Subject: NRC Requests for Additional Information (RAI) Related to the Audit of the Economic Simplified Boiling Water Reactor (ESBWR) Steam Dryer Design Methodology Supporting Chapter 3 of the ESBWR Design Control Document – Draft Response for RAI 3.9-286

Draft Response for RAI 3.9-286

NRC RAI 3.9-286

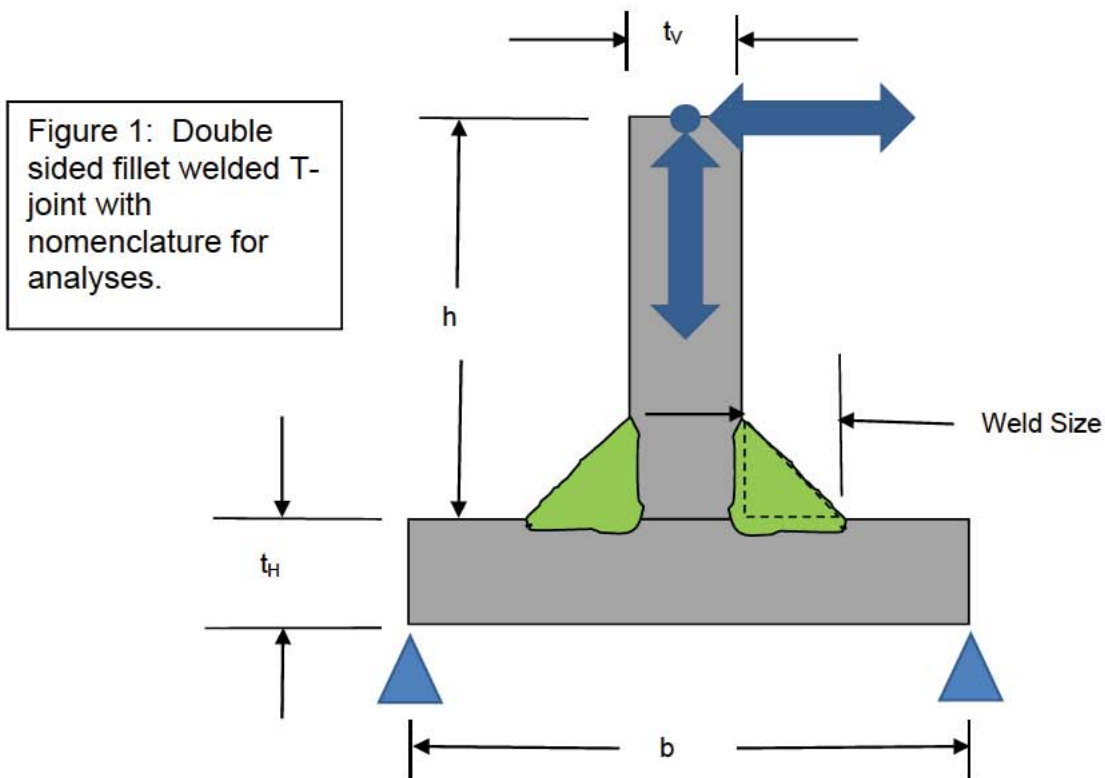
During the audit, the staff and GEH also discussed the solid element submodel approach identified in Section 4.1 and Figure 4-1 of Reference 1, for predicting the alternating peak stress intensity for the fatigue evaluation of fillet welds. This method is applied when [REDACTED] (top of page 6 of 37).

In prior RAI responses, GEH has stated that the submodel approach is used when [REDACTED], and that the submodel approach leads to reduced stresses. The staff inquired how many submodels are typically developed. GEH indicated that for GGNS, there are [REDACTED] developed. Alternating peak stress intensity at all of her locations are based on the shell model results. In a solid element submodel, the fillet is added. The fillet representation in the submodel is textbook – triangular with the design leg length. While multiple solid elements are used [REDACTED]. As stated in Reference 1, top of page 6 of 37, "... [REDACTED] [REDACTED]."

As an adjunct to the parametric study comparing methods (1) and (2) for shell models (see Question 4), the staff requests GEH to develop alternating peak stress intensity predictions using the solid element submodel approach for a representative set of cases, and to compare the results with the corresponding method (1) and method (2) results. Include one example calculation that demonstrates the procedure defined in the statement quoted in the preceding paragraph.

The discussion about submodels during the 2012 NRC staff audit was with respect to RAI 3.9-215S01 Part B (ref. 1). In RAI 3.9- 215S01 response GEH stated relatively few places needed the application of [[
]].

Licensing topical report NEDE- 33313P-A (ref. 2) states if the
